Landscape Review Committee
Community Development Center, 231 NE 5th Street
February 20, 2019
12:00 PM

DATE: February 20, 2019
TO: McMinnville Landscape Review Committee
FROM: Jamie Fleckenstein, PLA, Associate Planner
SUBJECT: Agenda Item 4A: L 18-18

DECISION, CONDITIONS OF APPROVAL, FINDINGS OF FACT, AND CONCLUSIONARY FINDINGS OF THE MCMINNVILLE LANDSCAPE REVIEW COMMITTEE FOR APPROVAL OF A REVISED LANDSCAPE PLAN FOR A NEW COMMERCIAL SHELL BUILDING AT 711 NE HIGHWAY 99.

APPROVED LANDSCAPE PLAN

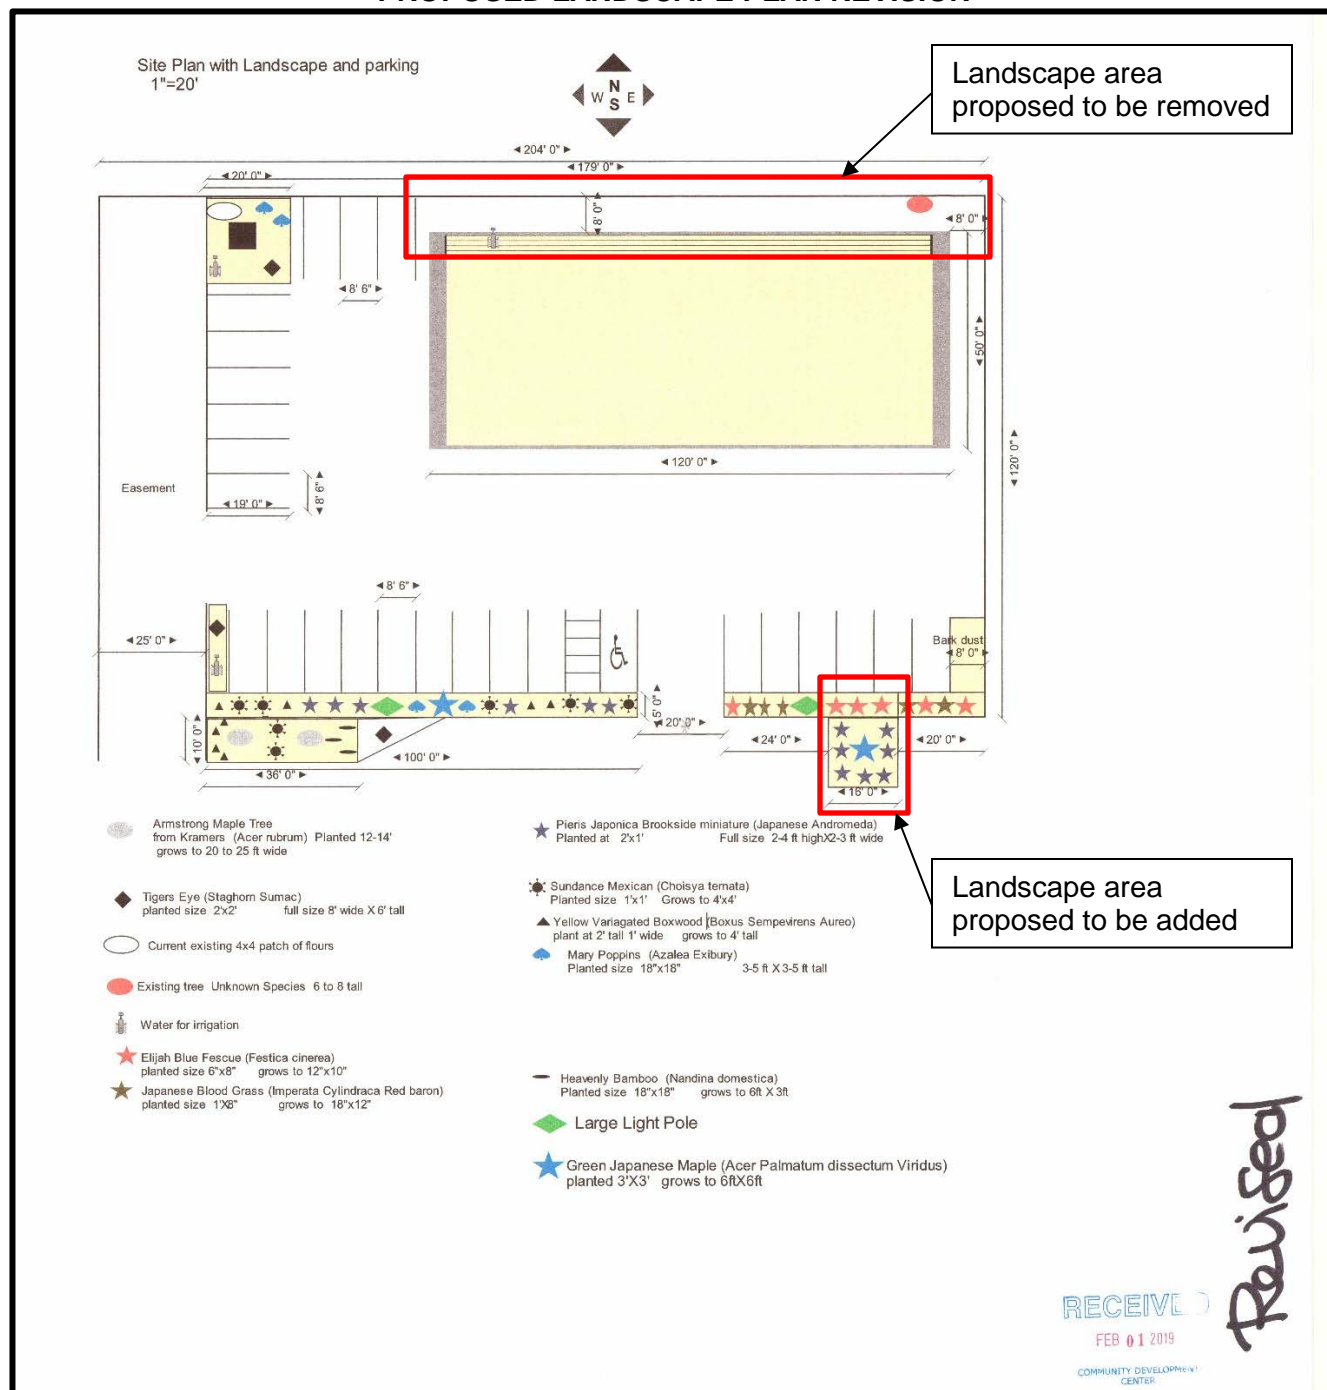
Although removal of that landscape area would leave landscaping in excess of the seven (7) percent minimum requirement, the applicant is proposing to add additional landscaping in front of the parking lot. The application indicates that the area proposed to be a concrete pad for trash containers in the approved landscape plan is no longer necessary, and the revised landscape plan shows a 336 square foot planting area in that location. The applicant has proposed a Green Japanese Maple tree (*Acer palmatum dissectum* 'Viridus') surrounded by the small evergreen shrub Brookside Miniature Andromeda (*Pieris japonica* 'Brookside Miniature') for that space. Three (3) new Elijah Blue Fescue (*Festuca cinerea*) in the planting area adjacent to the parking would be consistent with the previously approved planting in that area.

The proposed revision to the landscape plan is compatible with the proposed development and its uses. While the revised landscaping would remove some planting only visible from the occasionally used church parking lot to the north, the new proposed landscaping would be in a more highly visible area and provide more aesthetic appeal to the public right-of-way along Highway 99 and to the highly visible front façade of the new building.

1. That the applicant shall install landscaping as shown on the revised landscape plan received by the Planning Department February 1, 2019.
2. That the applicant shall maintain proper clearances around the future water and electrical services that will be located within the planting area near the entrance to the site. Landscaping shall not be placed within four (4) feet of fire hydrants, within four (4) feet of water valves, within four (4) feet of vaults, within three (3) feet of the back or side of a transformer, or within one (1) foot of water meters. The front side of a transformer requires a minimum clearance of 10 feet, in a pie

3. That the Japanese Blood Grass and Elijah Blue Fescue be planted at a spacing of 18 inches on center throughout the southeastern landscape area in front of the parking spaces.
4. That all landscaping approved by the Landscape Review Committee and required as conditions of approval shall be maintained, including necessary watering, weeding, pruning, mowing, and replacement.

PROPOSED LANDSCAPE PLAN REVISION

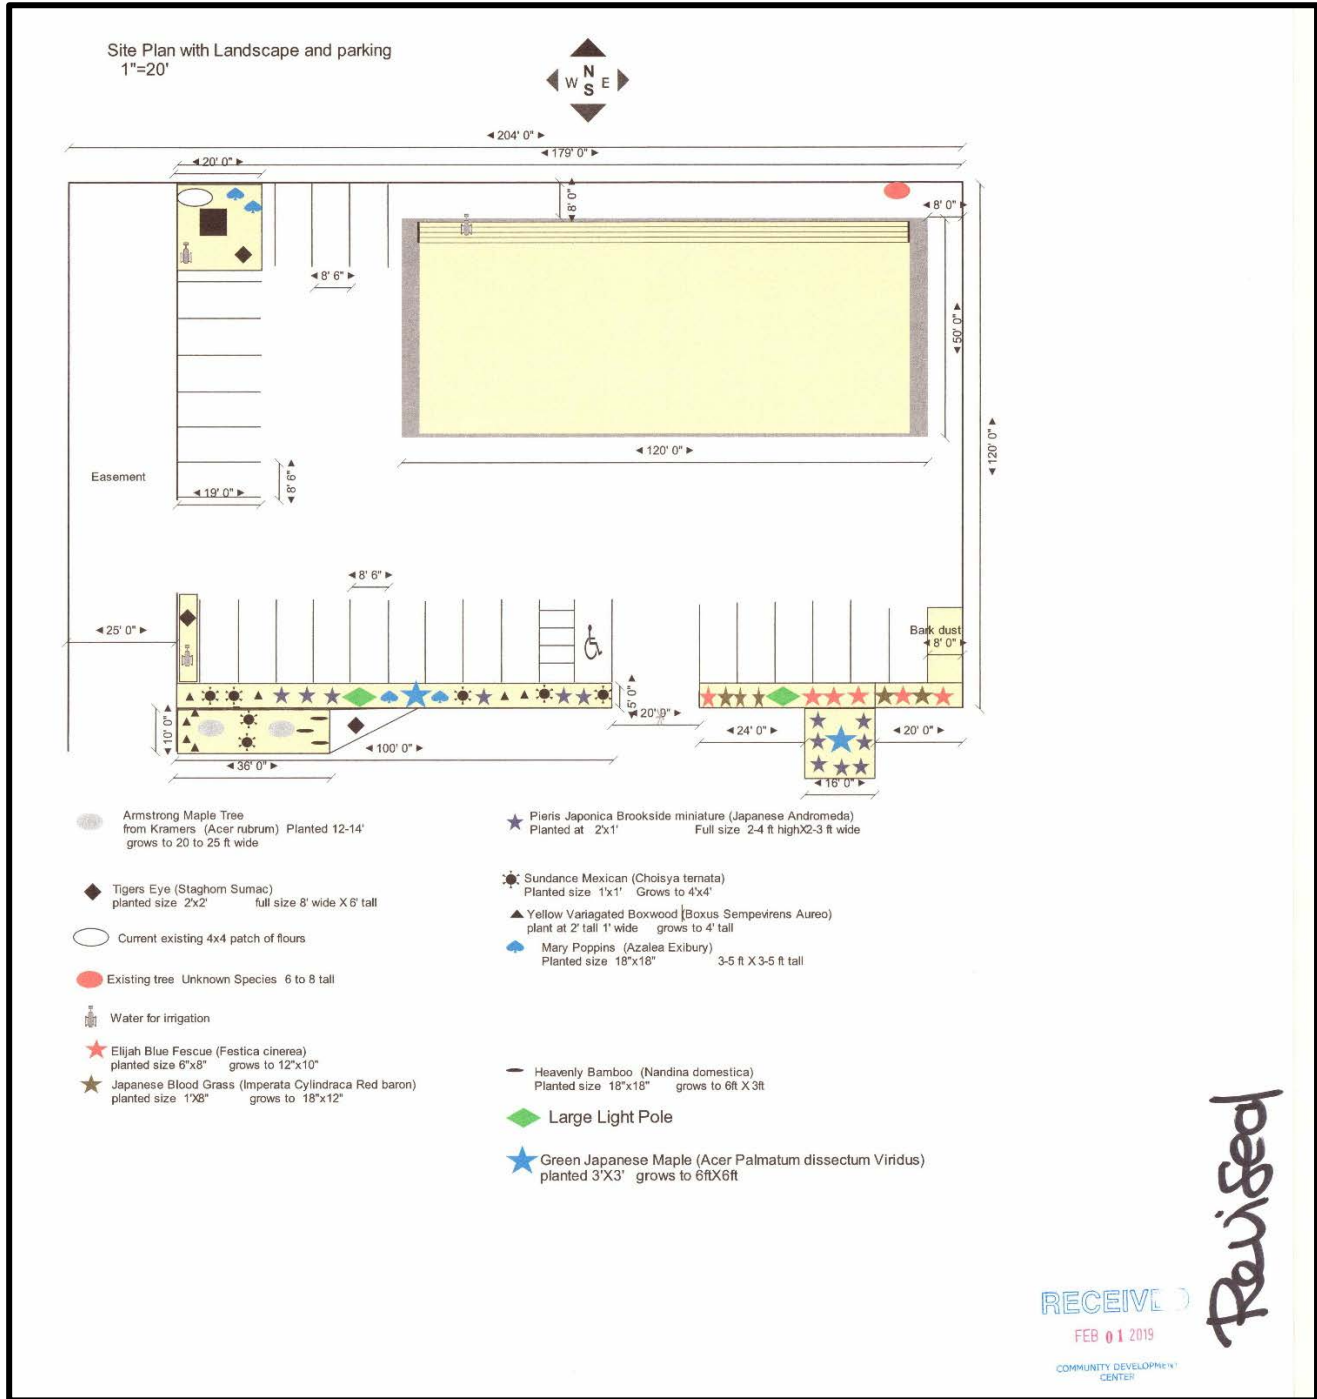
The proposed revision removes 600 square feet of planting area on the north side of the new building and replaces it with 336 square feet of planting to the south of the parking lot in front of the building. Adjacent to the north side of the development area is a large parking lot for a church located northwest of the subject site. To the south of the development area is the Sandwich Express restaurant and parking lot. The development area is visible from Highway 99 to the south.

The applicant indicated a potential lessee of one of the tenant spaces in the new building may want to access their space from the north side of the building. That, in addition to the difficult growing conditions (deep shade on the north side of a building) and the limited visibility of that space, warranted proposing its removal. The space is currently covered in gravel as a result of building construction. Planting in that area on the approved landscape plan included a total of 19 shrubs and one (1) existing tree. The approved planting was a mix of evergreen shrubs, generally around four (4) feet in height. The existing tree is to remain, although the planting area around it is no longer proposed.

The new proposed landscaping replaces an area previously dedicated to trash receptacles in a highly visible location. The small Green Japanese Maple tree and low evergreen shrubs will provide additional screening of the parking lot from the Highway 99 public right-of-way. The additional planting in this area will provide more screening and buffering of the new building from the adjacent restaurant and parking to the south, and from Highway 99.

1. That the applicant shall install landscaping as shown on the revised landscape plan submitted to the Planning Department in February 1, 2019.
2. That the applicant shall maintain proper clearances around the future water and electrical services that will be located within the planting area near the entrance to the site. Landscaping shall not be placed within four (4) feet of fire hydrants, within four (4) feet of water valves, within four (4) feet of vaults, within three (3) feet of the back or side of a transformer, or within one (1) foot of water meters. The front side of a transformer requires a minimum clearance of 10 feet, in a pie slice shape. Minor adjustments in plant placement from the locations shown on the approved landscape plan are allowed if relocation is necessary to meet minimum clearances.

4. That the Japanese Blood Grass and Elijah Blue Fescue be planted at a spacing of 18 inches on center throughout the southeastern landscape area in front of the parking spaces.

INDOOR BATTING CAGE LANDSCAPE PLAN

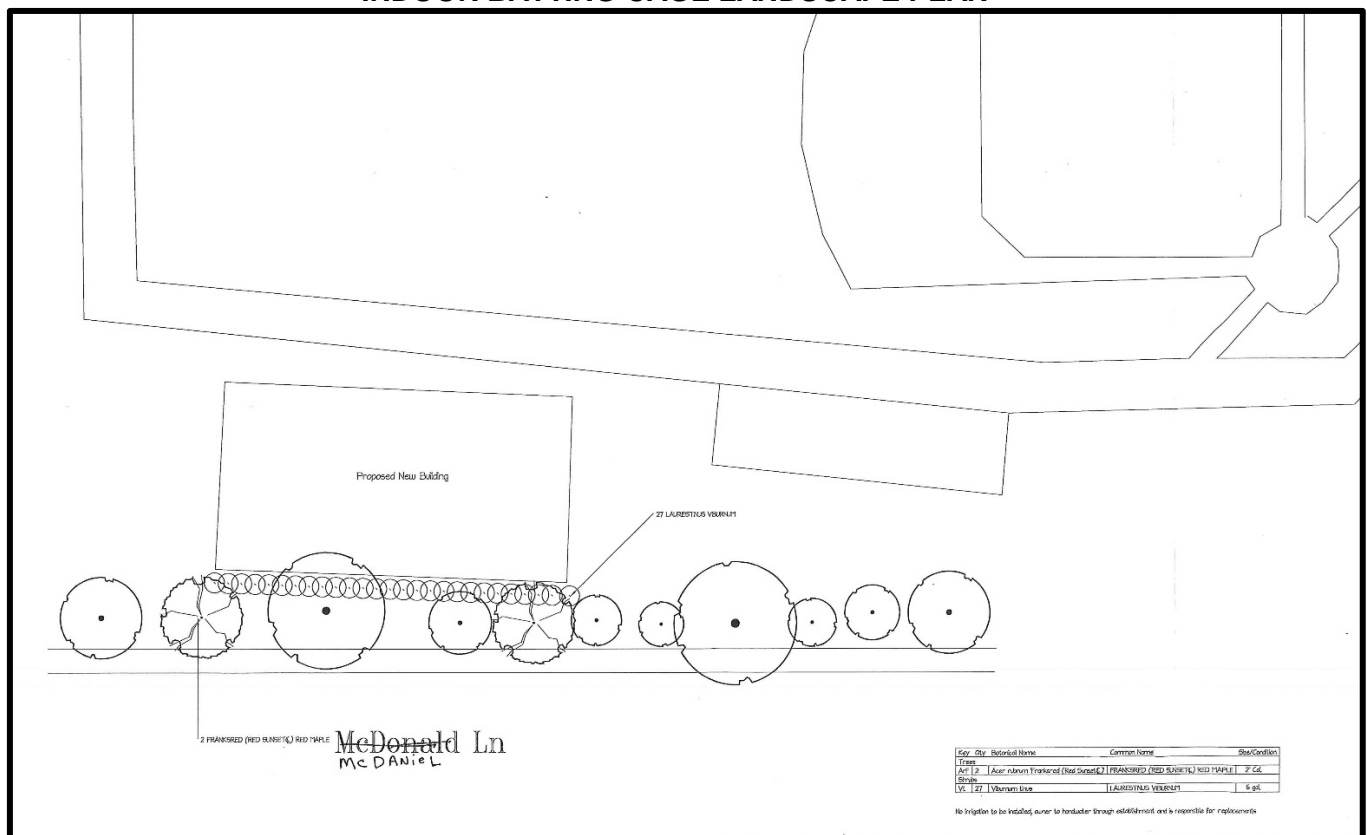
The landscape plan as proposed exceeds the required seven (7) percent landscaping requirement. The applicant indicates the total building floor area of the new structure is 5,760 square feet. 864 square feet of landscaping is proposed as part of the project, or 15 percent of the total development area. The proposed landscape plan also includes improvements to the existing pedestrian walkway.

BASEBALL FIELD – EXISTING TREES

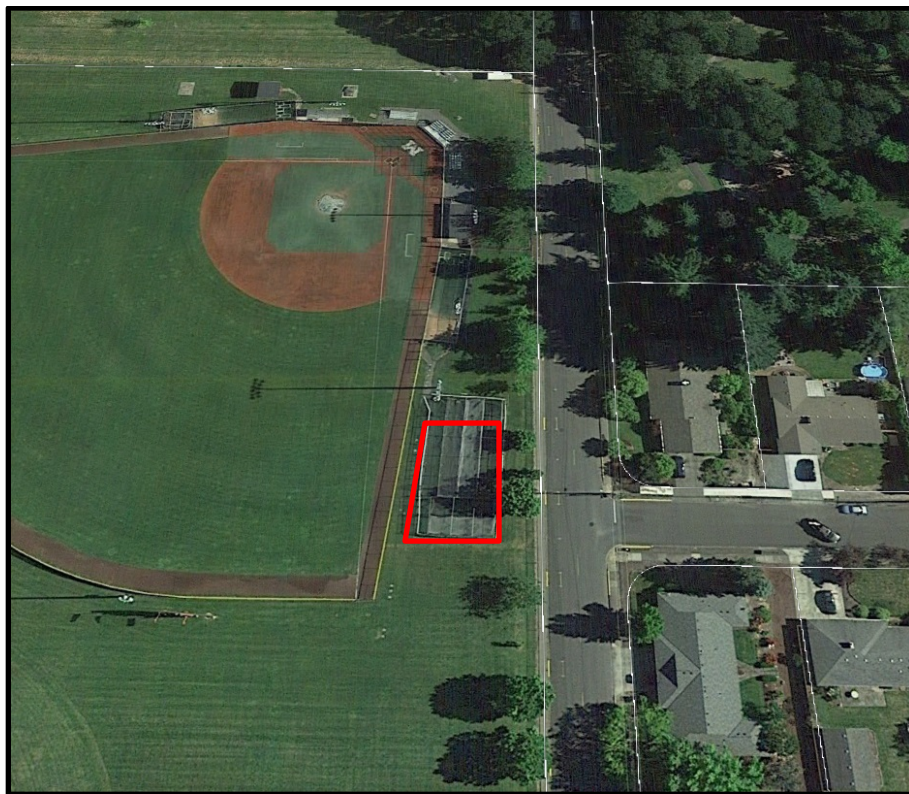
On the subject site, between the area of proposed development and the McDaniel Lane right-of-way, are 18 mature oaks and maples, ranging in size from 19 inches to 66 inches in diameter at breast height (DBH). The proposed project does not include removal of any of the existing trees. The landscape plan also proposes to plant two (2) new *Acer rubrum* 'Franksred' (Red Sunset Red Maple) to fill in gaps in the existing row of trees and their canopy.
